INTRODUCING THE NEW DEKK

HERCULES

SKIDSTEER RUBBER TRACK RANGE

RE-DESIGNED TREAD PATTERN

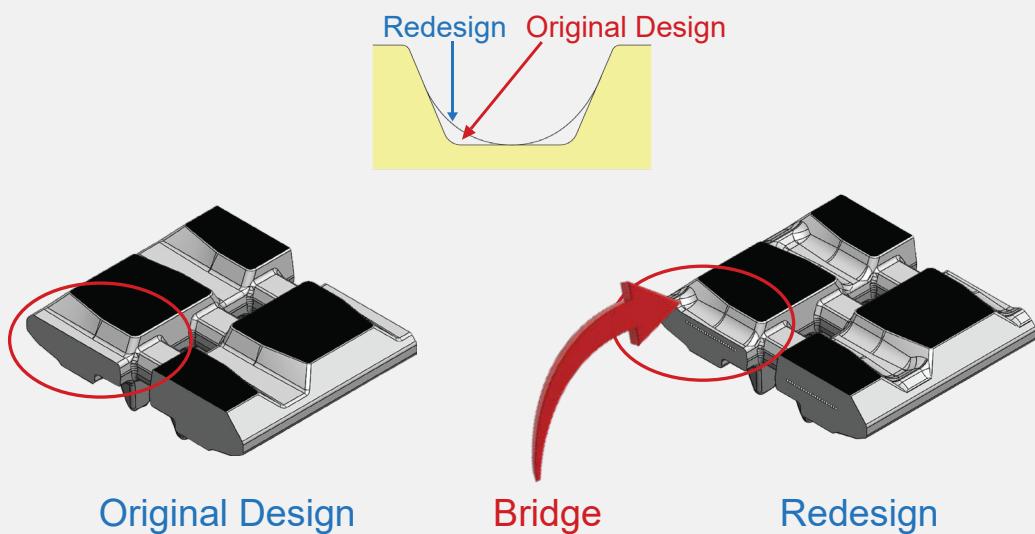
1 Redesigned the tread pattern by adding the Hercules Armour between the treads to absorb machine operating forces and protect the track from the outside. Resulting in a massive 16.5% decrease in stress on the track.

2 Redesigned the edge profile of the treads to reduce the concentrated force at the base of the treads to re-direct the force on the track and further protecting the core of the track

3 Upgraded reinforcement of the tracks by using a 15% higher tensile steel cable than other brands, further strengthening the carcass of the track.

4 Changed cable locations to deeper in the rubber and increased cable reinforcement to optimise overall structural integrity
